Staff Report to Council

FILE: 08-3060-20/24-03

REPORT DATE: January 06, 2025 **MEETING DATE:** January 14, 2024

SUBJECT: Development Permit Application for 19516 Hammond Road

Figure 5: Site Plan

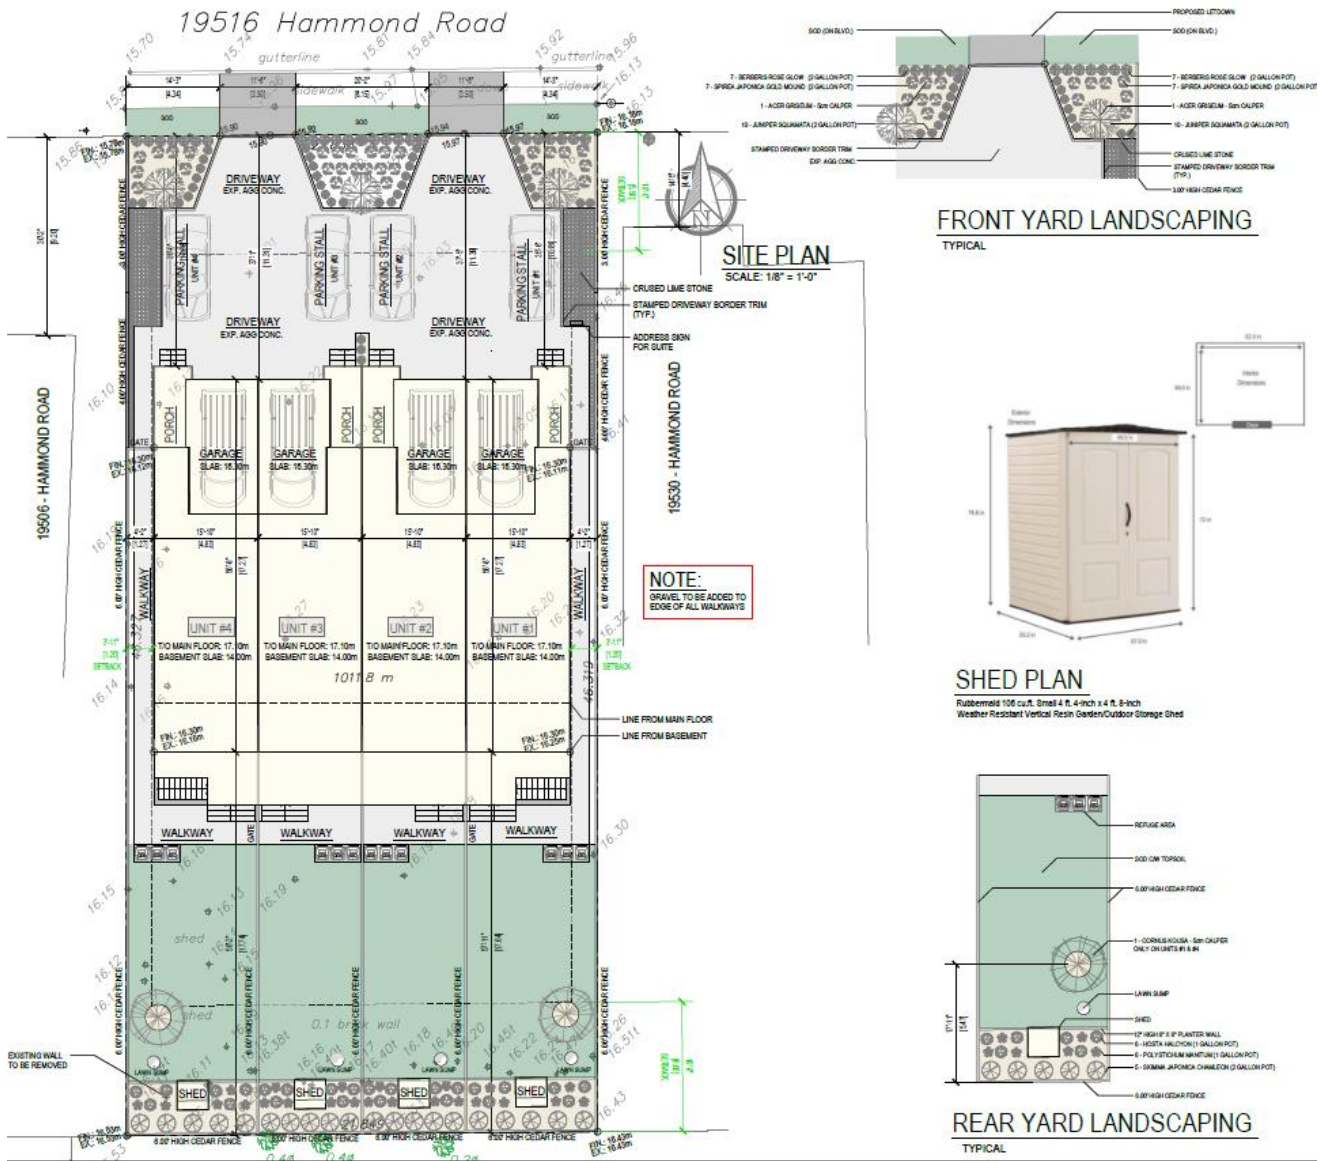
This development proposal features four townhouses facing Hammond Road and one basement suite accessed from the rear of the building (Figure 5). Each townhouse unit includes three bedrooms plus a den, offering 2,095 ft² of living space on the main and upper floors, with an additional 691 ft² in the basement. Only unit one contains a basement suite (labelled unit 5 in the plans; see Attachment D). Unit one includes 200 ft² of private outdoor deck space, units two and three have 256 ft² each, and unit four has 220 ft². Each townhouse also has a single-car garage and a parking space in the front driveway. Access to the site is proposed via two shared driveways from Hammond Road.

Staff provided additional information on relevant policies and bylaws that recommend minimizing the number of driveways for improved safety and sidewalk accessibility. ADP members had varied perspectives on the dual driveway proposal:

- Safety concerns about vehicles backing out onto Hammond Road across the sidewalk and bike lane.
- The front yard and parking areas appear cramped; a previous single-driveway design appears to offer more on-site maneuvering space for vehicles.
- Suggestion to push the building back to improve parking and on-site vehicle maneuvering.
- The two-driveway option allows easier straight-line backing out and accommodates an additional tree at the front.
- Sightlines restricted by 3.5m-wide driveways; consider slightly widening the driveways.

The revised plans submitted by the applicant (Attachment D) address most of the remaining concerns identified above; however, two issues remain unresolved. The first is the proposed dual driveway design, and the second is the placement of the suite address sign, which was not relocated as recommended.

In alignment with the City’s Highway Access Bylaw, the development permit guidelines, and the Province’s Active Transportation Design Guide that recommend minimizing the number of driveways, staff recommend the applicant amend the proposal to use a single shared driveway access and accommodate on-site vehicle maneuvering. Minimizing the number of driveways improves safety for pedestrians and people riding bikes or using mobility aids. This is consistent with past practice for other small multi-family and townhouse developments in Pitt Meadows, such as the approved 4-unit townhouse development at the corner of Blakely and Hammond Roads.

On-site maneuvering is another aspect to consider to avoid vehicles needing to reverse onto a busy street, across the sidewalk and bike lane. A shared on-site parking area with a shared driveway is more likely to allow vehicles to turn around on-site and exit forward onto Hammond Road.

Overall, the proposal does comply with the intent of the relevant design guidelines, except for the number of driveway access points and visibility of the basement suite address. The recommendation is to direct the applicant to revise the site design to employ a single driveway access. If this recommendation is adopted, the revised design would then come back to Council for further review.

- A. Direct the applicant for Development Permit No. 2024-003, proposing a four-unit townhouse building with one basement suite at 19516 Hammond Road, to amend the plans to include a single driveway access and sufficient on-site vehicle maneuvering for further consideration; OR
- B. Other.

By requiring each lot to utilize a single shared driveway and have sufficient on-site maneuvering space, the City can minimize unnecessary access points and maintain the safety and functionality of Hammond Road for all users. As more four- to six-unit developments are anticipated, it is important, in staff's opinion, to establish best practices that prioritize safety, active transportation, and efficient land use.

Figure 9: Rear Yard Landscaping

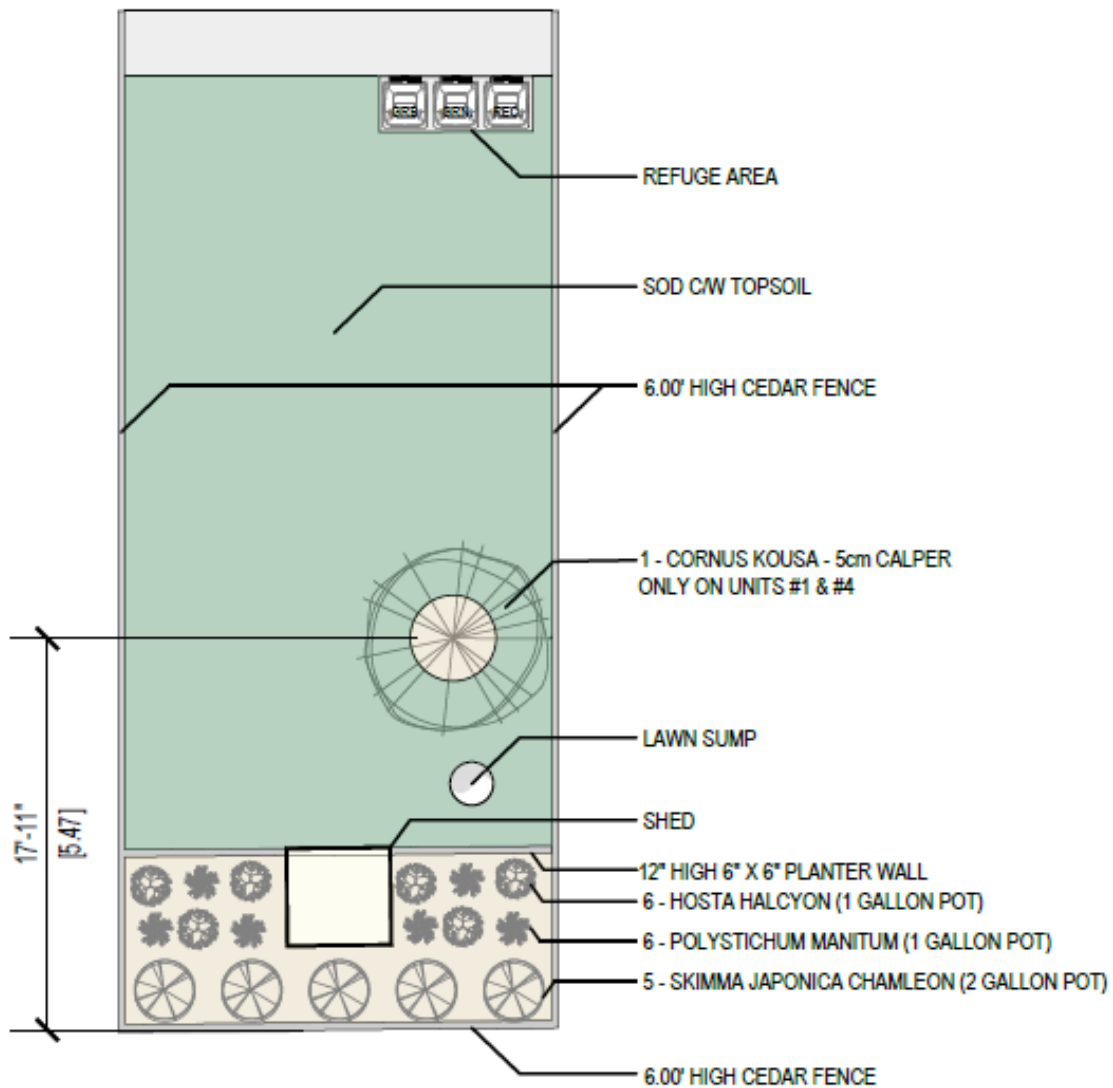
- The central backyard dogwood trees may limit recreational use and the roots could affect lawn areas. Suggested moving these to yard corners.
- Having the additional trees aligns with the City's urban canopy goals.
- The paperbark maple trees in the front are a suitable species for that area but should be shifted south to improve sightlines for departing vehicles and canopy clearance from the sidewalk.

- Use gravel or similar material between the side yard paths and fences to prevent maintenance issues.
- Address the gap between middle front porches with plantings or enclosures to avoid a maintenance issue.

Figure 10: Current number of driveways on Hammond Rd in blue

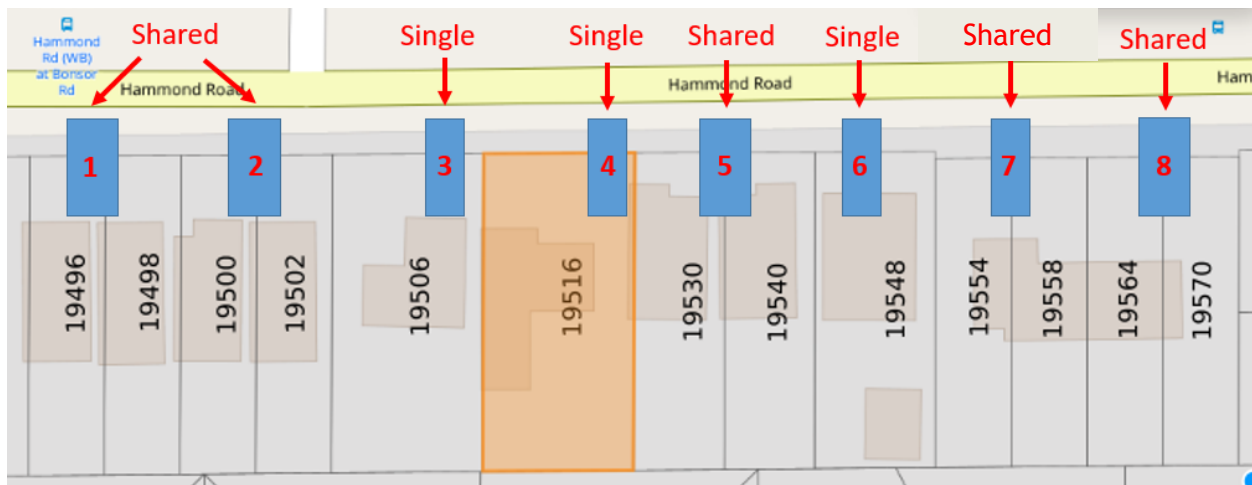
Figure 10 above illustrates the existing driveway distribution along Hammond Road, where 13 lots (including the subject property, highlighted in orange) collectively have eight driveways. Some of these are shared or single driveways, but notably, no lot currently has two separate driveways. The shared driveways were required by the City as part of the infill subdivision applications to limit the number of driveways accessing Hammond Road. Where adjacent shared driveways (e.g., between driveways #1 and #2 in figure 10) are approximately 12m apart, which accommodates one parking space and room on either side of the parked vehicle

Figure 11: Potential Driveways Along Hammond Rd.

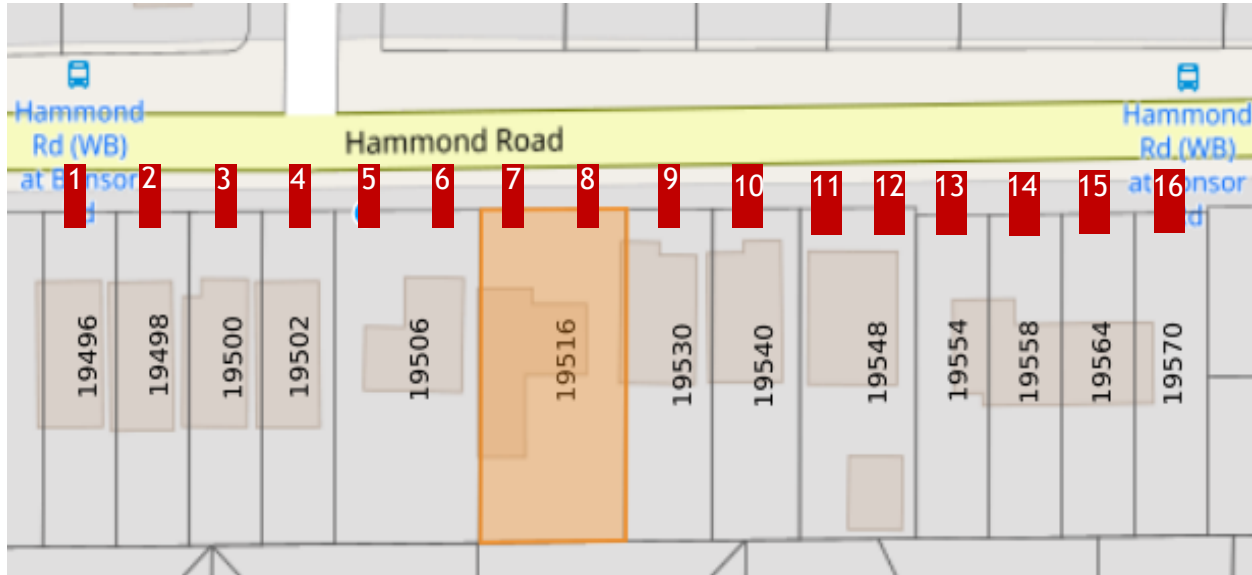
for turning vehicles and sightlines. 19516 Hammond Road is double the width of the lots with shared driveways and, therefore, would have double the number of driveways. Allowing a proportional number of driveways for future redevelopment, where narrower lots can have one driveway and wider lots can have two, would result in a notable increase, as shown below in figure 11.

Hammond Road is designated as an arterial road and bike route in the City's plans, and is a frequent transit route. Increasing driveway access points along a busy roadway elevates the risk of conflicts between vehicles and people using the sidewalk or bicycle lane, compromising safety and active transportation objectives. Additionally, frequent driveway letdowns create an uneven sidewalk that affects the accessibility, safety, and comfort for people that use mobility aids (e.g., wheelchairs, mobility scooters, walkers) by increasing the risk of trips and falls. Allowing multiple driveways on small lots would also limit opportunities for landscaping, street trees, and on-street parking.
